Access Compliance Report

Public Rights-of-Way

(Curb Ramps)

Intersection ID: 27176	Main Street: SPRING_ST	Cross Street: KNOX_AV	Location:	N
ADA ID: 09D336C769FD	Ramp Type: Perp	Initial Pass/Fail: Fail	Overall Compliance: No	Severity Score: 33.75
Codes/Mitigation Info/Possible Solution		Field Measurements/Component Compliance

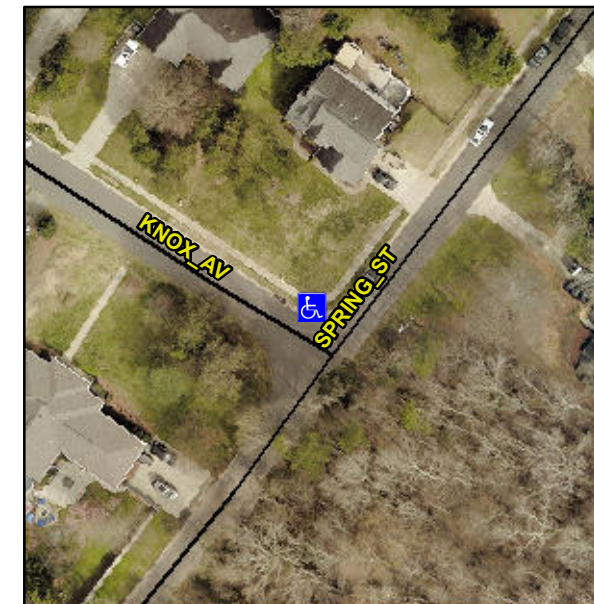
R304.5.1, R304.5.3

Compliance	Description	Data	Compliance	Description	Data
N/A	Ramp Length (in)	48.5	Yes	Ramp Slope (%)	7.1
No	Ramp Width (in)	38.5	No	Ramp XSlope (%)	10.7
N/A	Flare Type LT	N/A	N/A	Flare Type RT	N/A
N/A	Flare Slope LT (%)	N/A	N/A	Flare Slope RT (%)	N/A
N/A	Flare Traversable LT?	N/A	N/A	Flare Traversable RT?	N/A
N/A	Landing Length (in)	N/A	N/A	DWS Provided?	N/A
N/A	Landing Width (in)	N/A	N/A	DWS Contrast?	N/A
N/A	Landing Slope (%)	N/A	N/A	DWS Length (in)	N/A
N/A	Landing X Slope (%)	N/A	N/A	DWS Full Width?	N/A
N/A	Landing Curb? (Y/N)	N/A	N/A	DWS Offset (in)	N/A
N/A	Shared Landing?	N/A			
N/A	Gutter Ponding?	N/A	N/A	Gutter Slope (%)	N/A
N/A	Gutter Lip Ht (in)	N/A	N/A	Gutter X Slope (%)	N/A
N/A	Painted X Walk1?	No	N/A	Painted X Walk2?	N/A
	X Walk 1 Direction	To W		X Walk 2 Direction	N/A
N/A	X Walk 1 Width (in)	N/A	N/A	X Walk 2 Width (in)	N/A
	X Walk 1 Slope (%)	0.6		X Walk 2 Slope (%)	N/A
	X Walk 1 X Slope (%)	1.7		X Walk 2 X Slope (%)	N/A

Remove & Replace Entire Ramp.
